# Access Compliance Report

## Public Rights-of-Way

Intersection ID: 5632	Main Street: GRAYS_CREEK_LN	Cross Street: RIDGE_ACRES_RD	Location:	E
ADA ID: 5B48D448E318	Ramp Type: Perp	Initial Pass/Fail: Fail	Overall Compliance: No	Severity Score: 25
Codes/Mitigation Info/Possible Solution		Field Measurements/Component Compliance

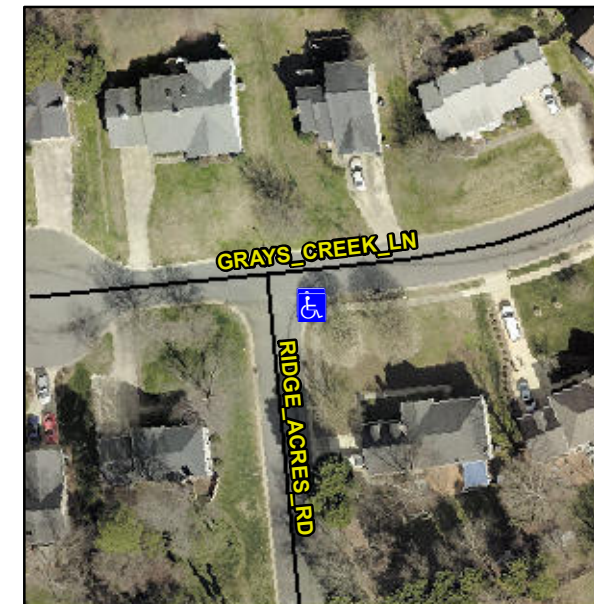
**Not Found, R304.5.3**

Compliance	Description	Data	Compliance	Description	Data
N/A	Ramp Length (in)	51.0	Yes	Ramp Slope (%)	6.2
Yes	Ramp Width (in)	48.0	No	Ramp XSlope (%)	8.0
N/A	Flare Type LT	N/A	N/A	Flare Type RT	N/A
N/A	Flare Slope LT (%)	N/A	N/A	Flare Slope RT (%)	N/A
N/A	Flare Traversable LT?	N/A	N/A	Flare Traversable RT?	N/A
N/A	Landing Length (in)	N/A	N/A	DWS Provided?	N/A
N/A	Landing Width (in)	N/A	N/A	DWS Contrast?	N/A
N/A	Landing Slope (%)	N/A	N/A	DWS Length (in)	N/A
N/A	Landing X Slope (%)	N/A	N/A	DWS Full Width?	N/A
N/A	Landing Curb? (Y/N)	N/A	N/A	DWS Offset (in)	N/A
N/A	Shared Landing?	N/A			
N/A	Gutter Ponding?	N/A	N/A	Gutter Slope (%)	N/A
N/A	Gutter Lip Ht (in)	N/A	N/A	Gutter X Slope (%)	N/A
N/A	Painted X Walk1?	No	N/A	Painted X Walk2?	N/A
	X Walk 1 Direction	To N		X Walk 2 Direction	N/A
N/A	X Walk 1 Width (in)	N/A	N/A	X Walk 2 Width (in)	N/A
	X Walk 1 Slope (%)	9.9		X Walk 2 Slope (%)	N/A
	X Walk 1 X Slope (%)	3.5		X Walk 2 X Slope (%)	N/A

**Remove & Replace Entire Ramp.**
